Millstone Nuclear Power Station, Unit No. 3
Transmittal of Amendment to FSAR/ER
Docket No. 50-423

Millstone Nuclear Power Station, Unit No. 3
Transmittal of Amendment 7 to the Environmental Report

INSERTION INSTRUCTIONS FOR AMENDMENT 7

FIGURE QE290.4-1
LOCATIONS OF LOUDSPEAKERS
TO BE PRESENT DURING PLANT
OPERATION
MILLSTONE NUCLEAR POWER STATION
UNIT 3
ENVIRONMENTAL REPORT
OPERATING LICENSE STAGE

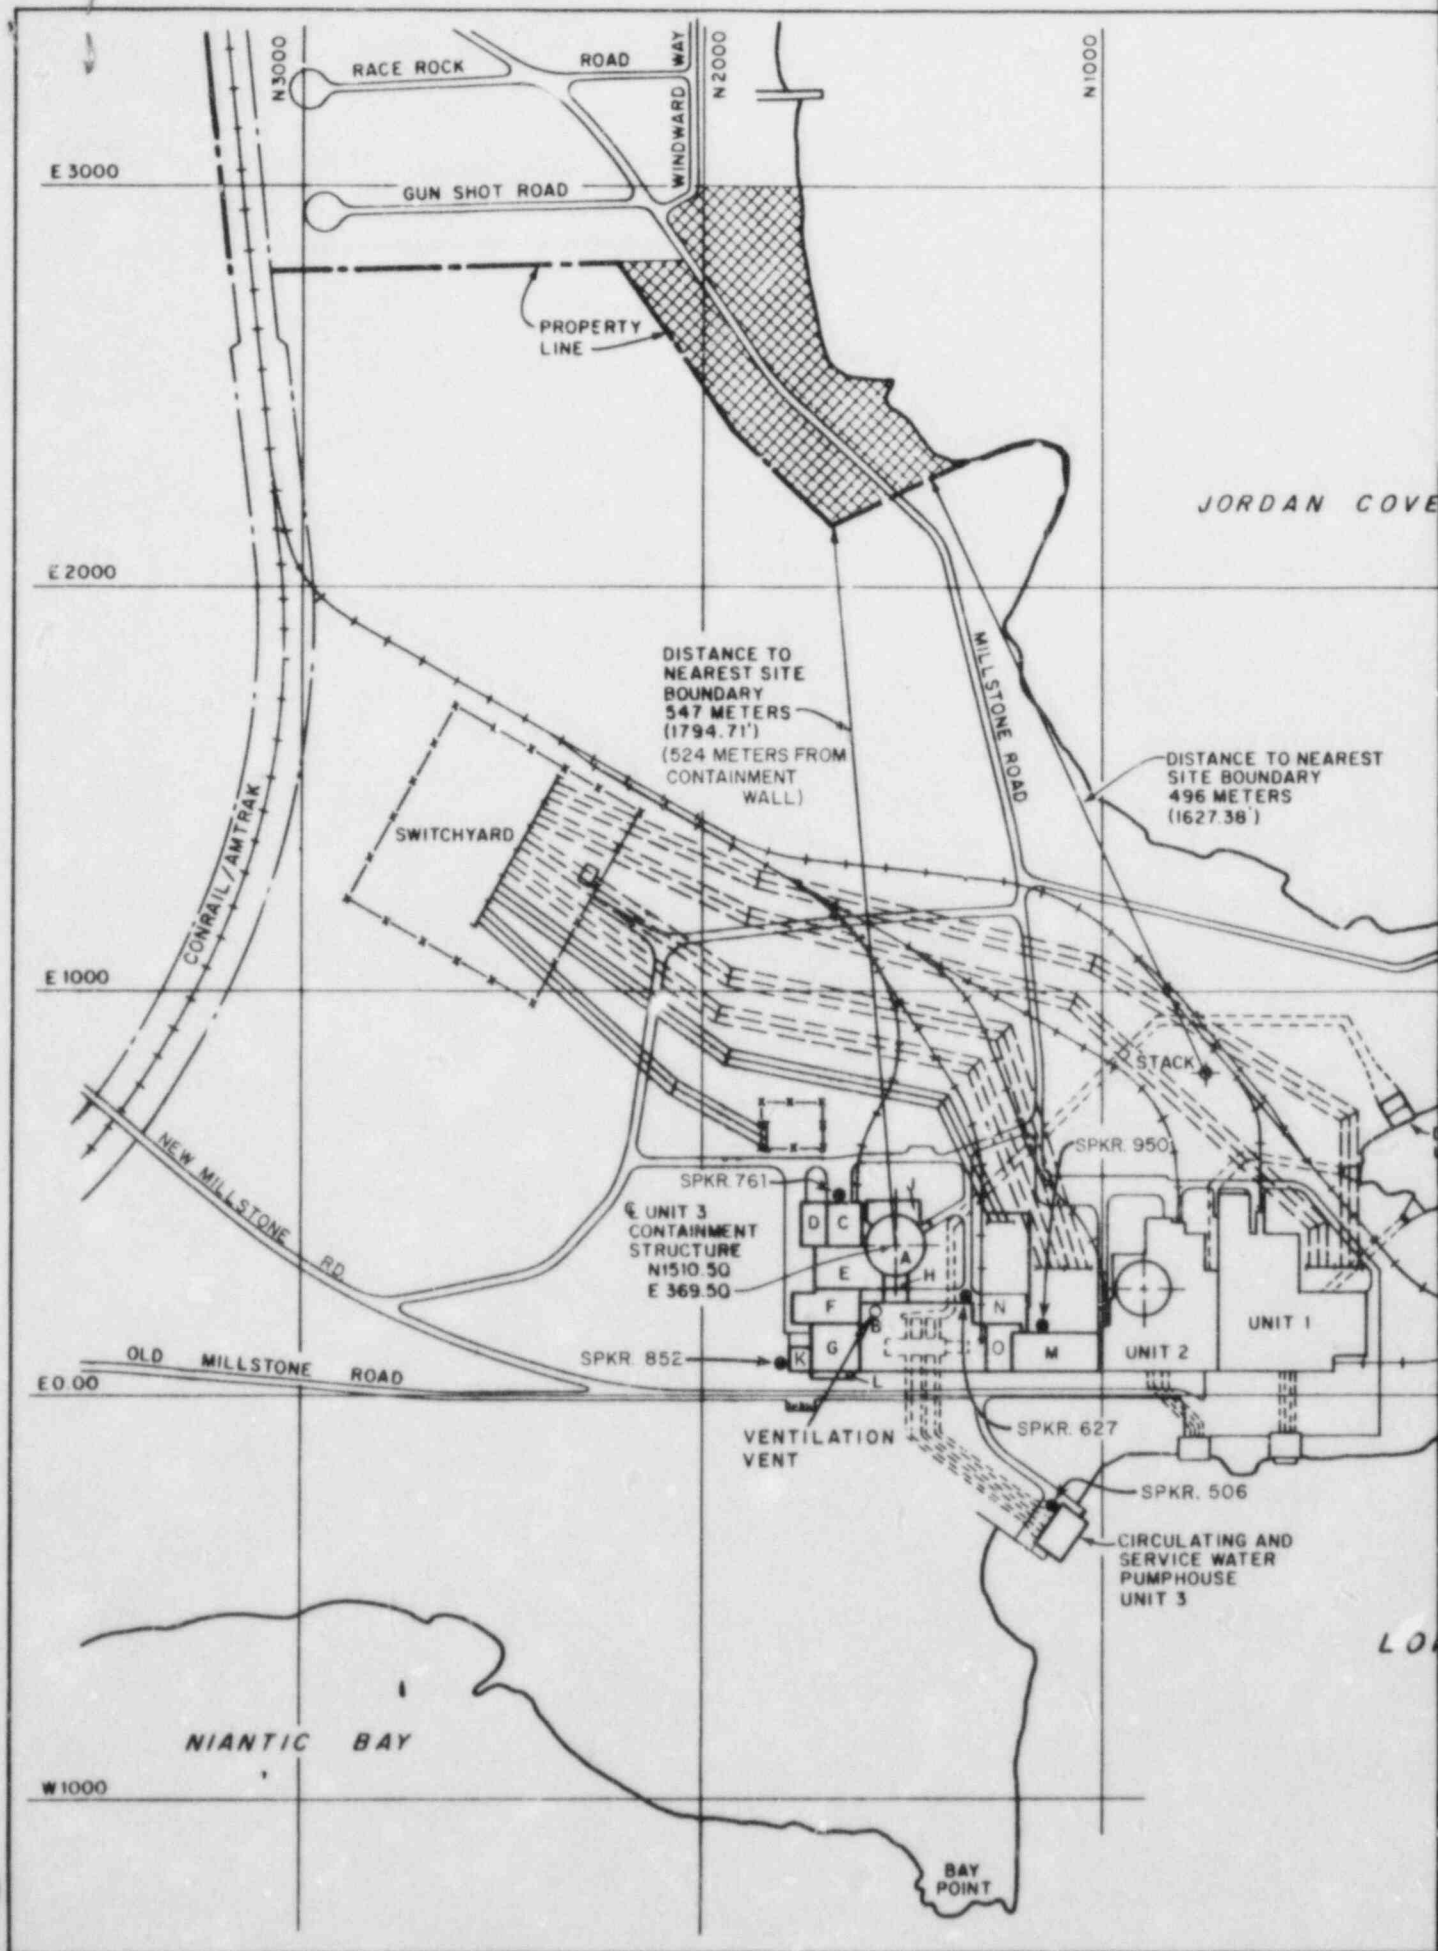
Provide a map containing the position of the loudspeakers that will be present during plant operation, and which may have an impact on Jordan Cove and Pleasant Beach. Indicate their coordinates and main axis of directivity.

There will be five loudspeakers present during plant operation. Their locations and directivities are shown on Figure QE290.4-1 and Table QE290.4-1, respectively.
